FROM: Schacht Aslani Architects - Jean Stolzman
TO: City of Santa Barbara
SUBJECT: Santa Barbara Museum of Natural History
DATE: 10 October 2011

SCHEME A - REVISED PRT

Santa Barbara Museum of Natural History Master Plan

Building Location/Fire Access/Circulation Diagram

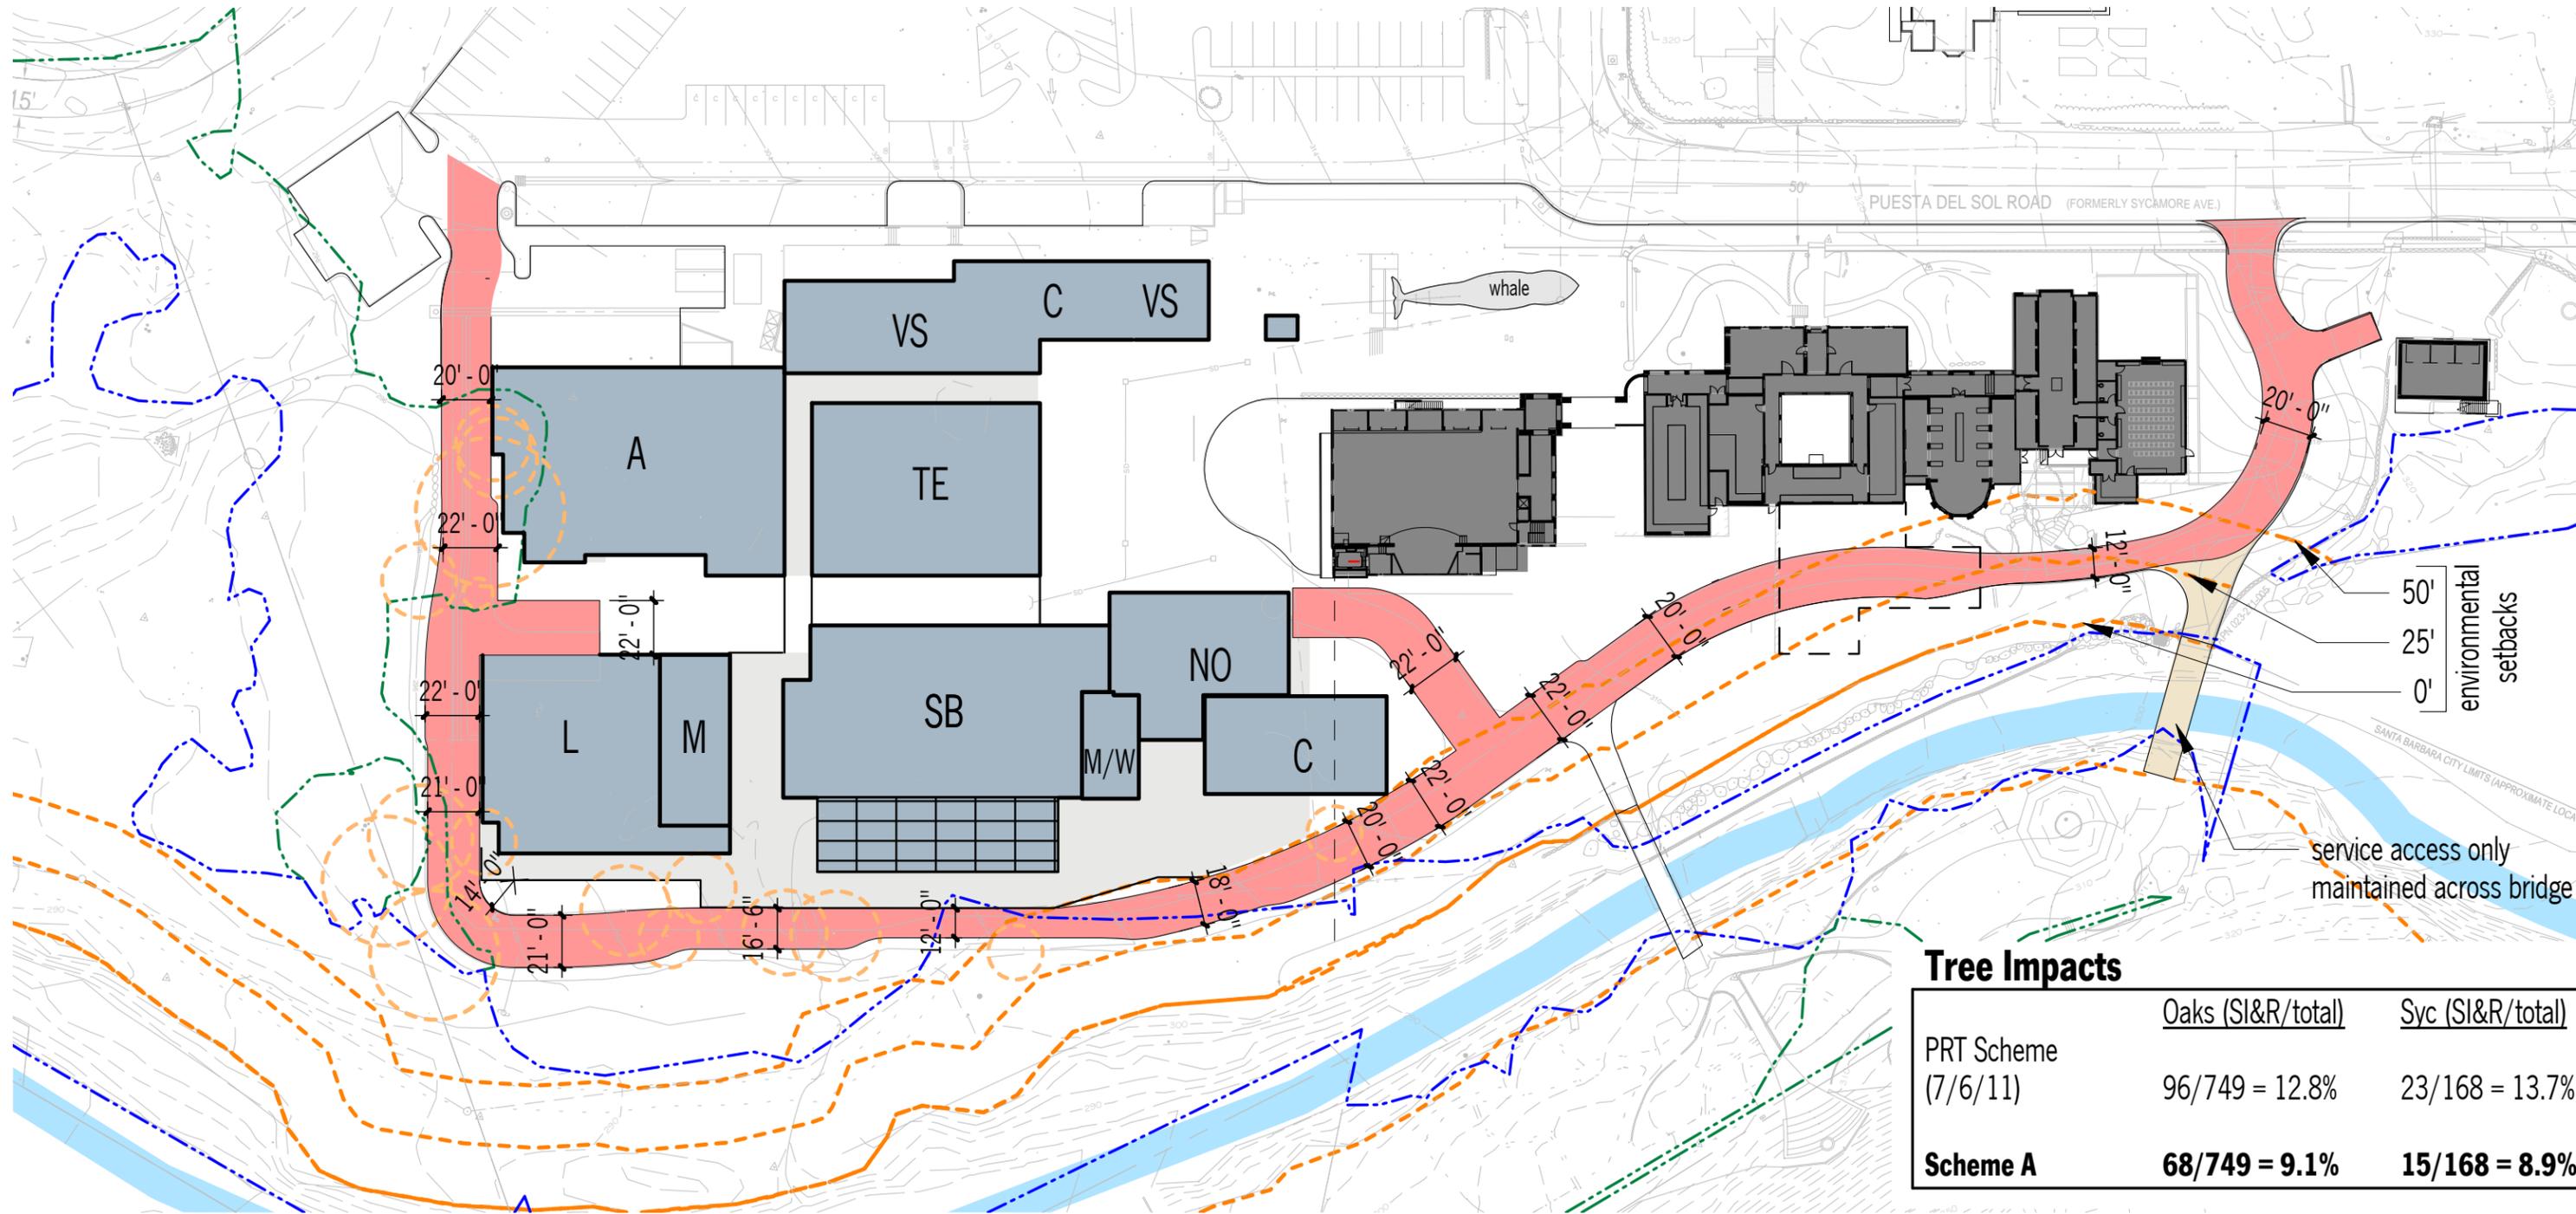
The attached diagram called 'Scheme A' has been moderately revised from the previous Site Plans presented to City Staff on 15 September. With further site planning we were able to fine tune biological impacts and mitigation recommendations. This diagram represents a revised footprint which includes building, Fire Department access and limits of grading and differs from the May and July 2011 PRT submittals (May was the initial submittal, followed by a revised July landscape submittal) in the following ways:

The overall Construction Phasing Plan was revised to demolish the existing Collections & Research Center in the first phase and thereby allow the Astronomy Courtyard to be reduced in size. This allows the proposed construction to move East roughly 30'.

This plan exhibits a reduction of building program of roughly 1,500 sf.

The Fire Department access road previously shown within the Oak Woodland in the West has been moved East and tight against the buildings. An independent fire consultant noted this provides a horizontal break between wild fires and buildings.

The Fire Department access road has been modified; it maintains a 20' wide dimension wherever possible but narrows in areas, as noted, to avoid tree impacts, the succulent garden and environmental setbacks as best as possible.

The Butterfly Pavilion has been relocated; it was previously shown South of Fleischman Auditorium and is now South of the Santa Barbara Gallery (SB). This placement maintains open space South of Fleischmann, allows Fire Department access to the Courtyard and offers a quieter, sunnier location for the butterflies.

Service access to Fleischmann's basement with the addition of a service elevator and stair has moved from the Southeast corner to the Southwest, as requested by our historian consultant.

The Service Yard has been reduced in length.

The above revisions has significantly reduced impacts to the Oak Woodlands to the West and eliminated impacts to the Riparian Woodland along Mission Creek. The total impacts and removal of Oaks is 9.1% and 8.9% to Sycamores.
